N60478.AR.000014  
NWS EARLE  
5090.3a

**State of New Jersey**  
**DEPARTMENT OF ENVIRONMENTAL PROTECTION**  
DIVISION OF WASTE MANAGEMENT  
HAZARDOUS SITE MITIGATION ADMINISTRATION  
CN 028, Trenton, N.J. 08625

RE: Naval Weapons Station Earle Health/Safety Plan and POAM by Weston

The following are the comments generated by the New Jersey Department of Environmental Protection after the review of the workplan by Weston for Naval Weapons Station Earle.

**FIGURE 11 SITE 19 - PAINT CHIP AND SLUDGE DISPOSAL AREA**

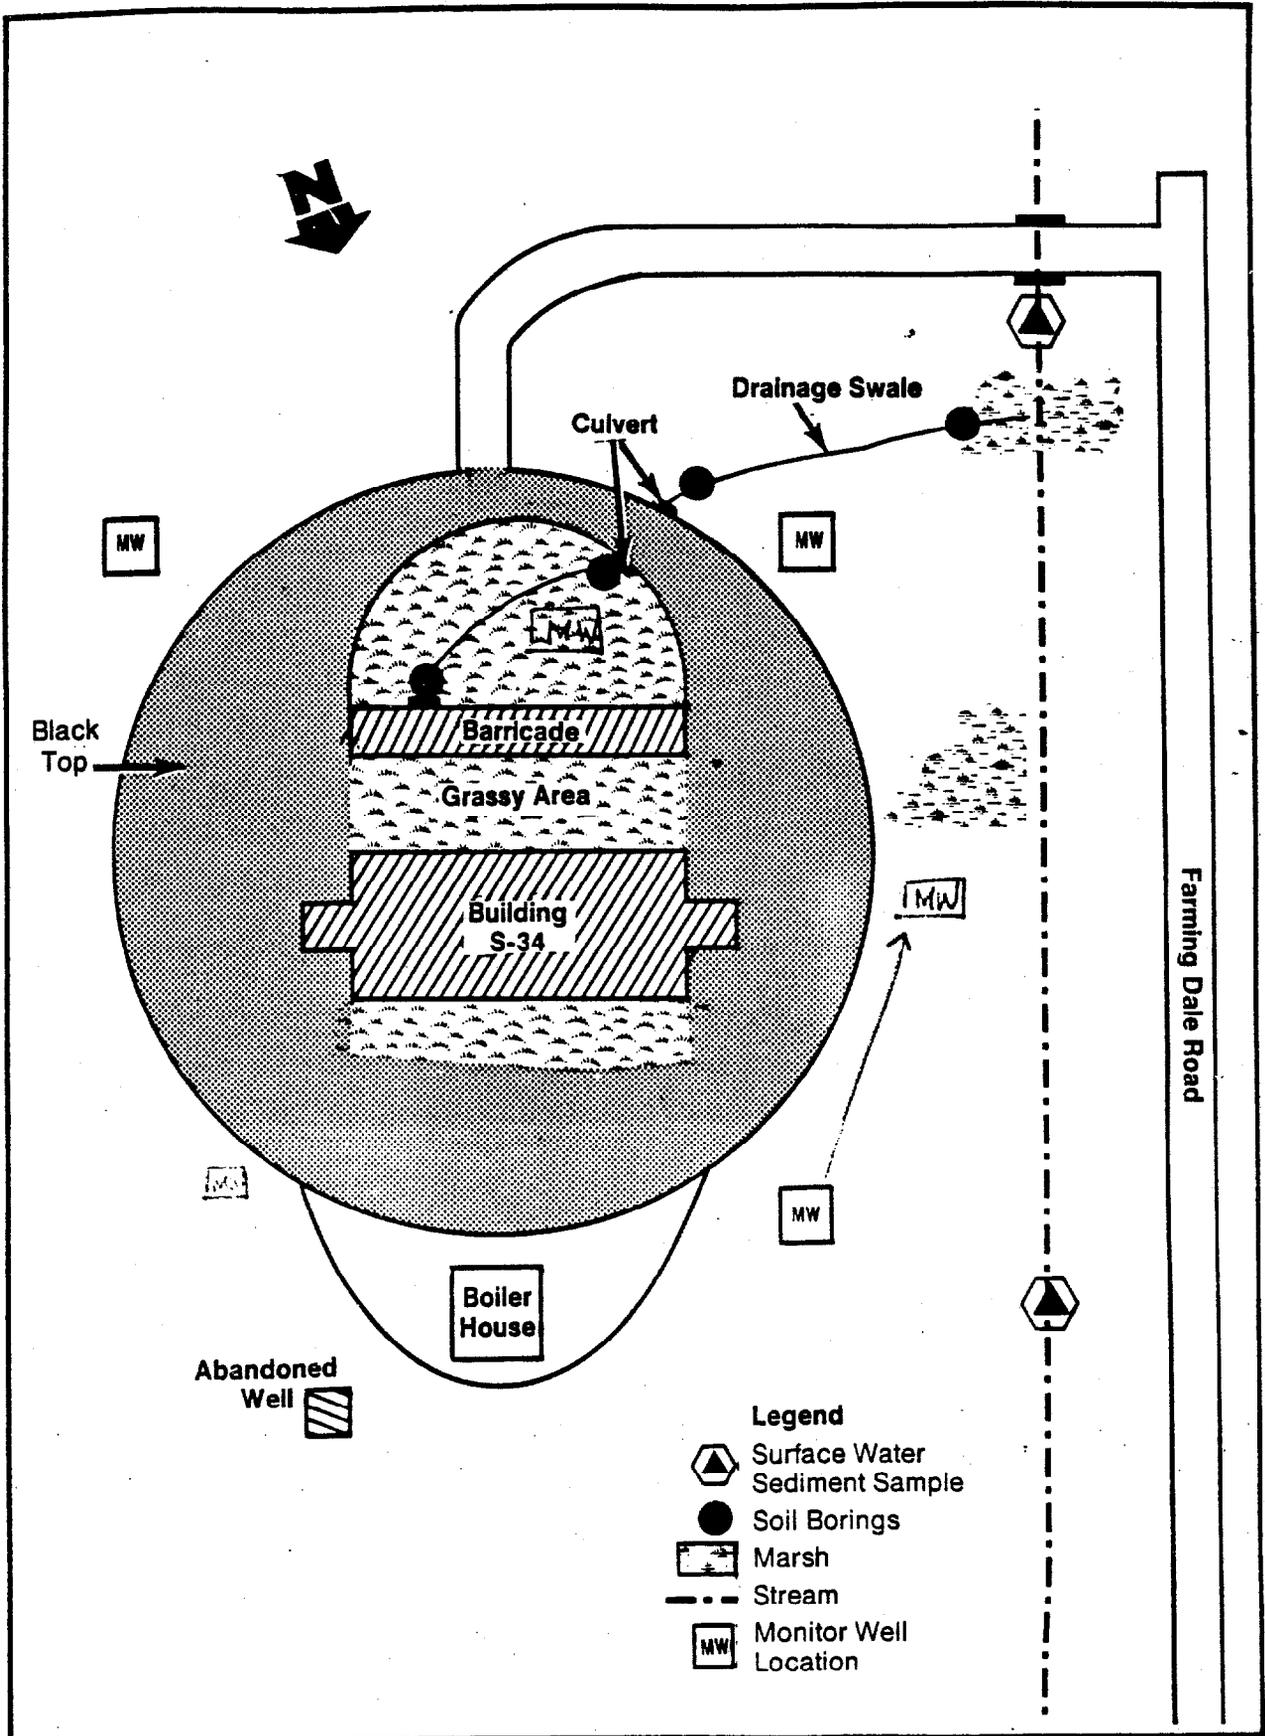
Please refer to Figure 7.

FIGURE 10 SITE 11 CONTRACT ORDINANCE DISPOSAL AREA

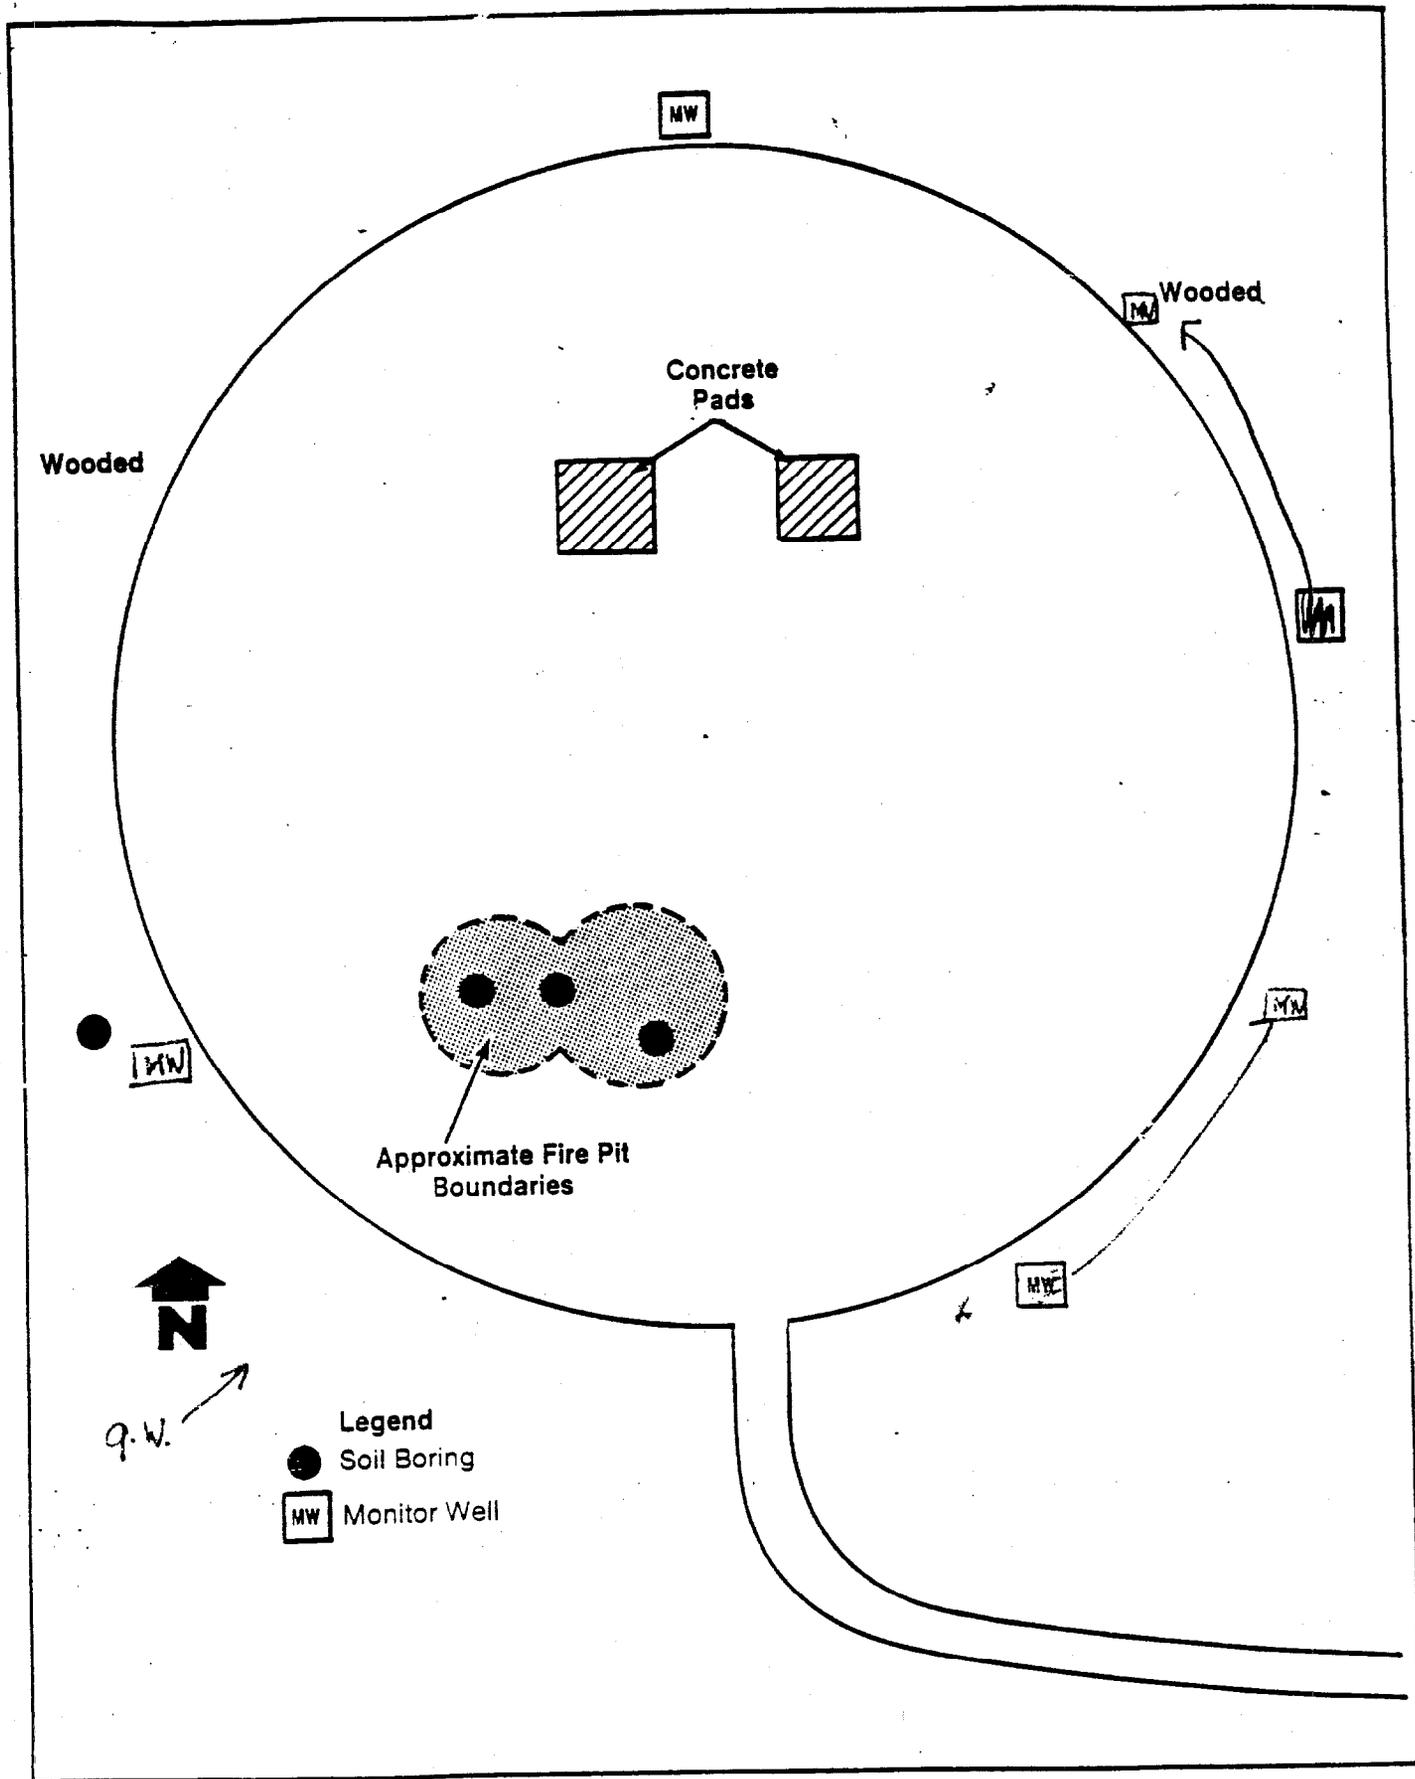
Add one well as indicated in the southwest quadrant of the site.

FIGURE 12 SITE 20 - GRIT BLASTING AREA AT BUILDING 544

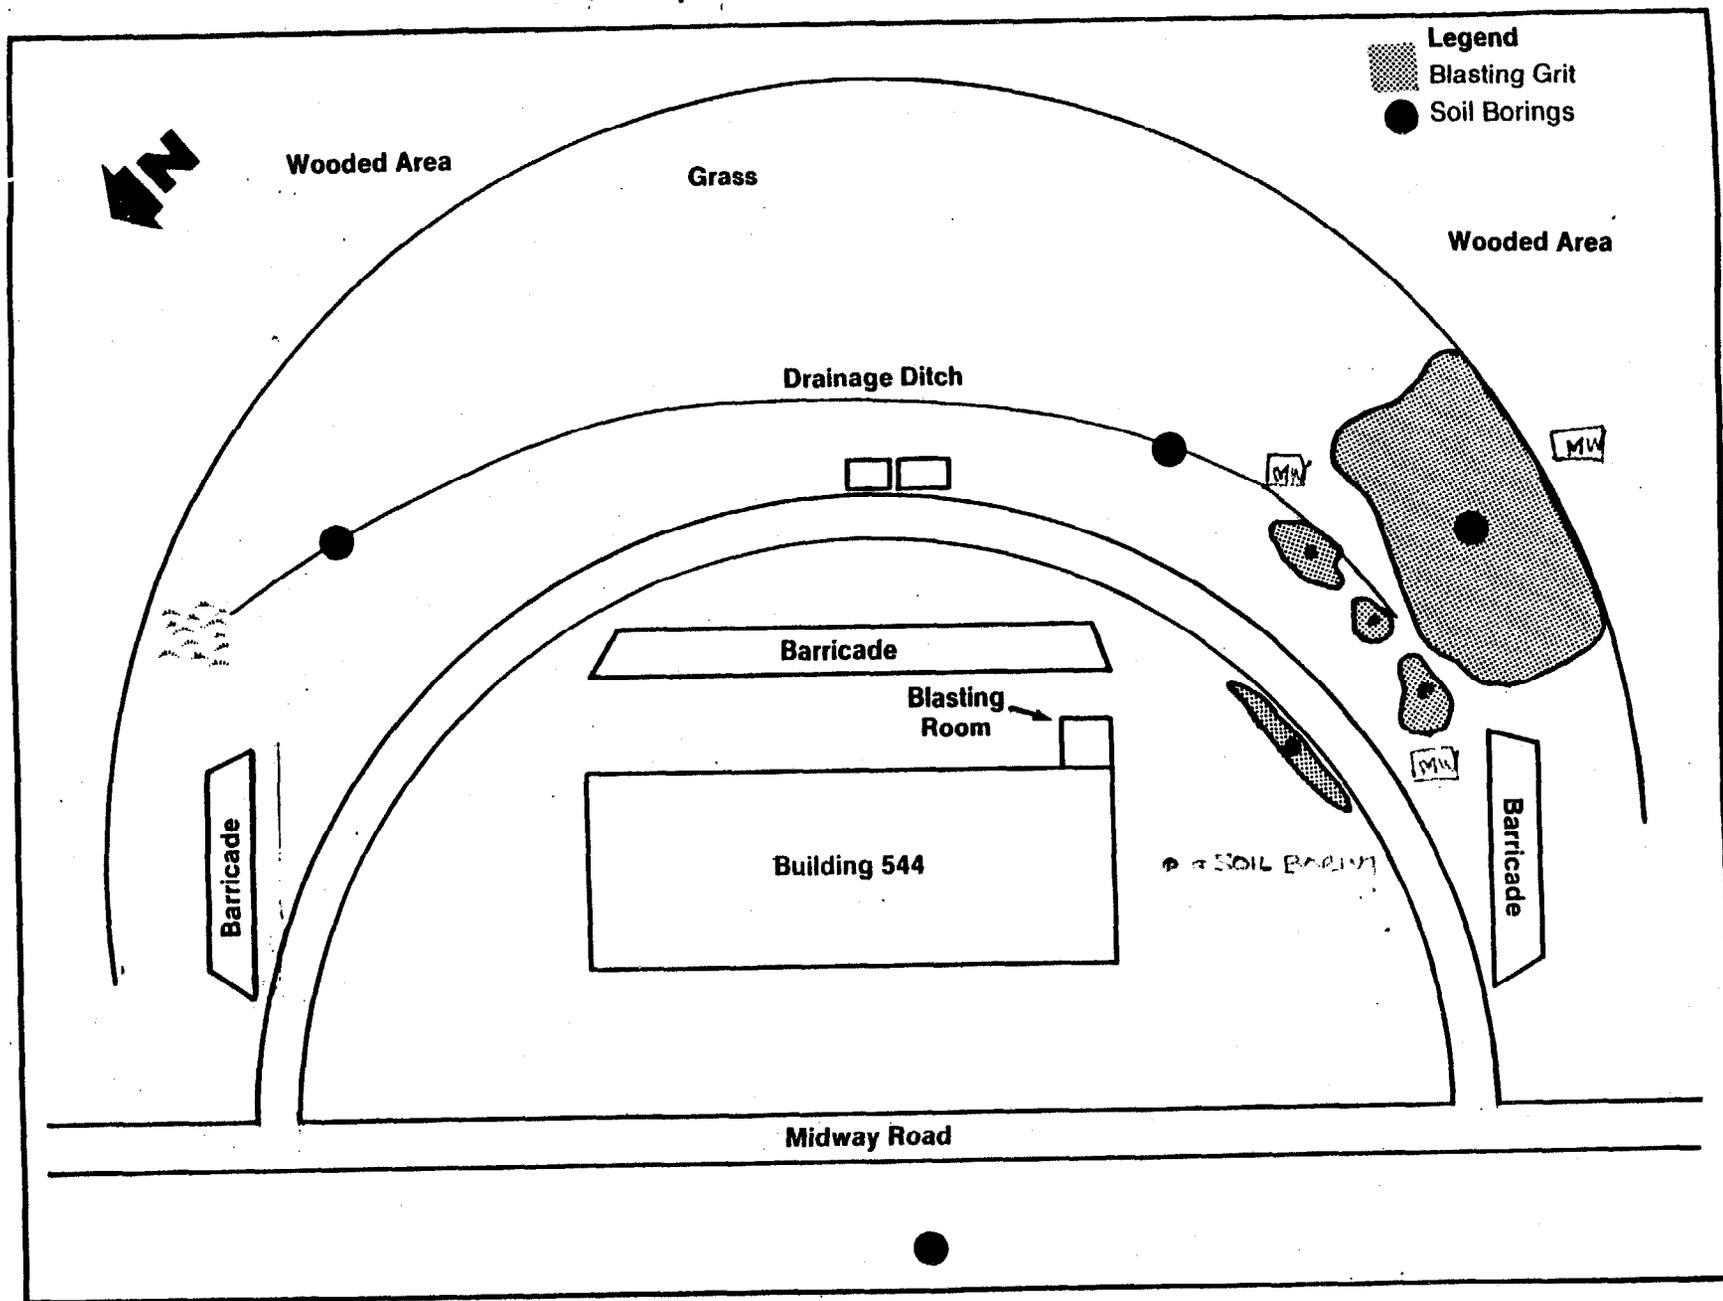
Refer to Figure 8

FIGURE 13 SITE 22 - PAINT CHIP DISPOSAL AREA

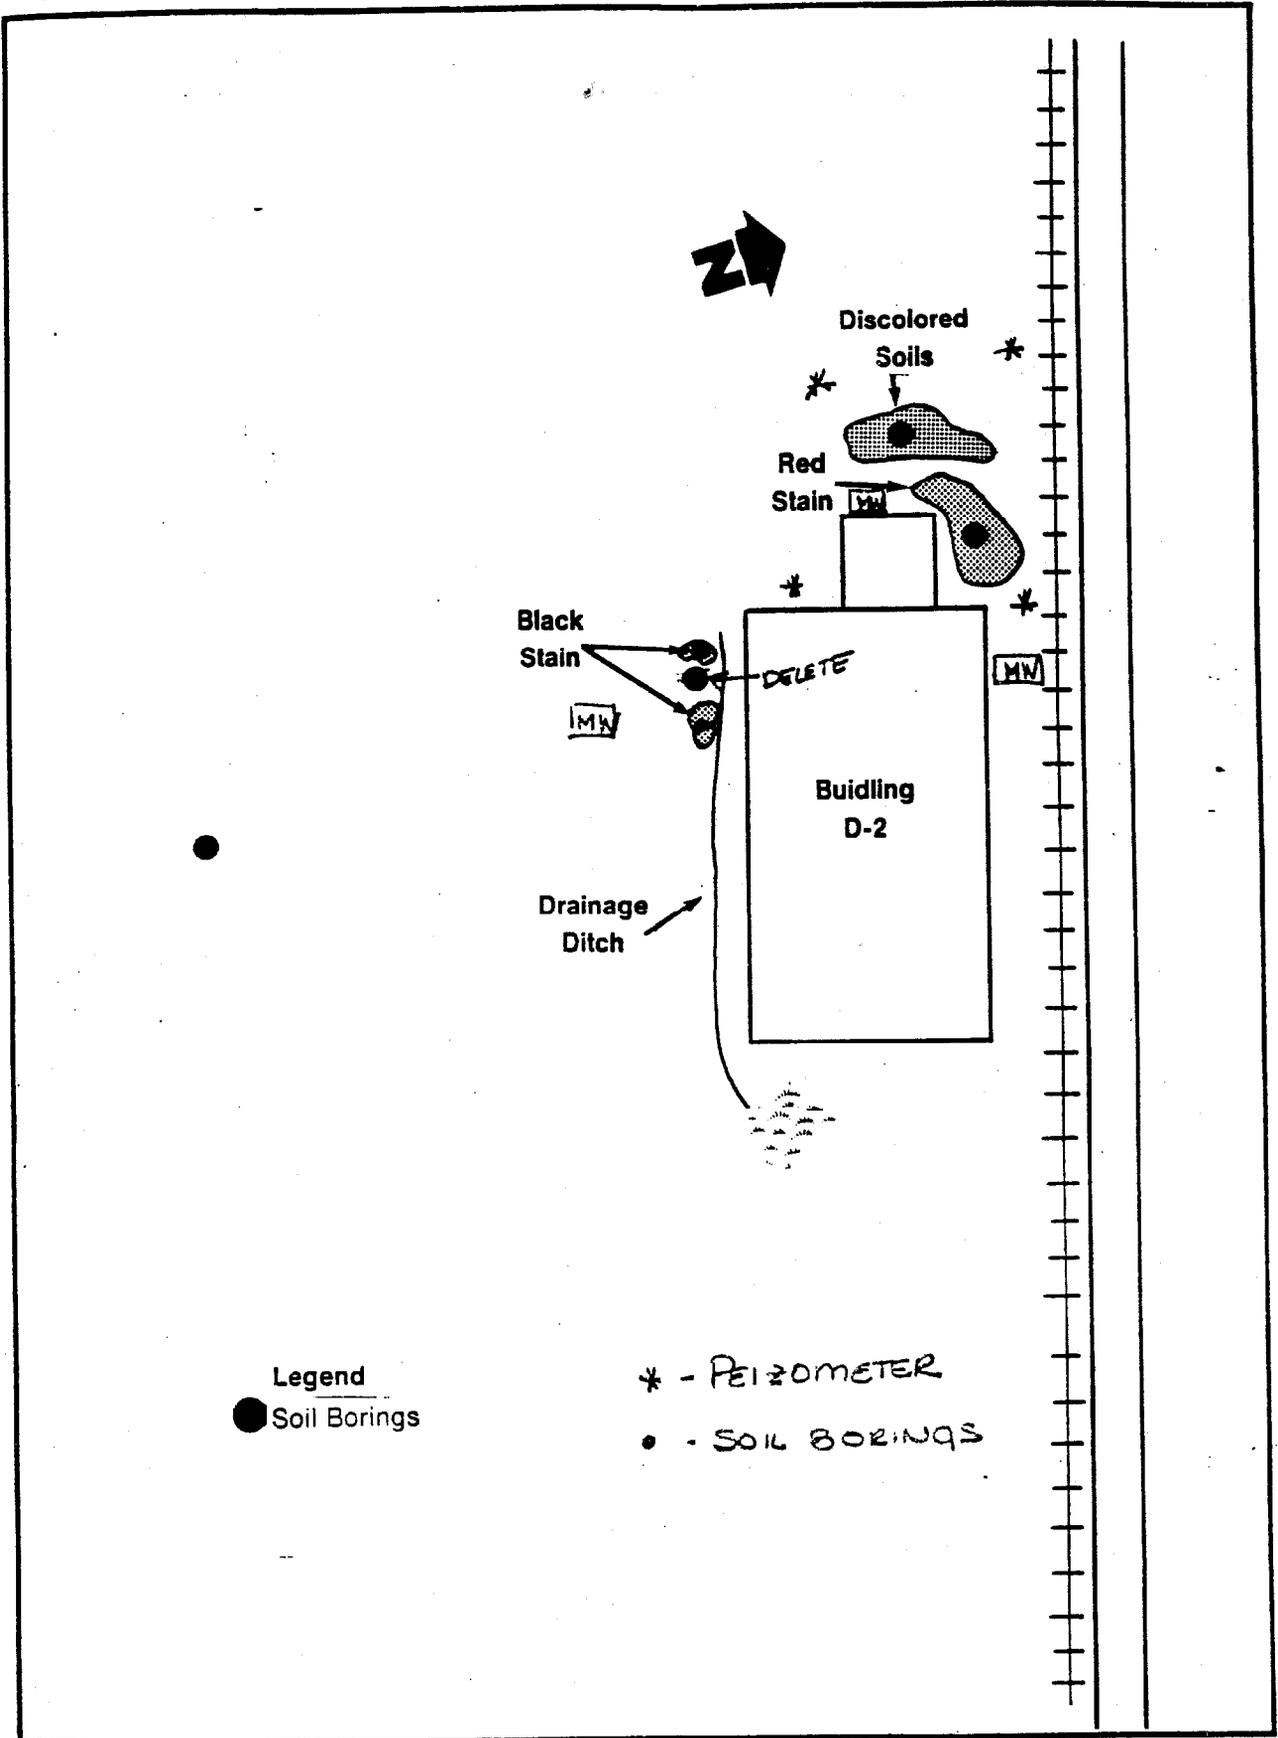
Refer to Figure 9
